Vehicle Speed Sensor  
CHU, CXU, GU, TD

## FSB 386-007, Vehicle Speed Sensor

(November 2014)

W3094986

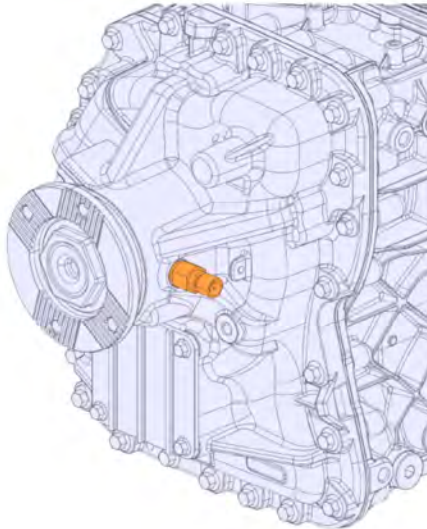
- 4 Remove the VSS from the transmission.

**Note:** If sensor part number 3171490 is found to have been installed and needs to be replaced, this sensor is also replaced with 22387296.

**Note:** If a gasket or shim is present between the sensor and transmission discard it **DO NOT** reuse with new sensor.

- 5 Install the new VSS onto the transmission and secure (part # 22387296).

- 6 Tighten the VSS to 25 ± 5 Nm (18 ± 3.7 ft-lb)
- 7 Connect the harness to the VSS.
- 8 Install all the previously removed cables to the negative (ground) battery terminals.
- 9 Remove the wheel chocks.
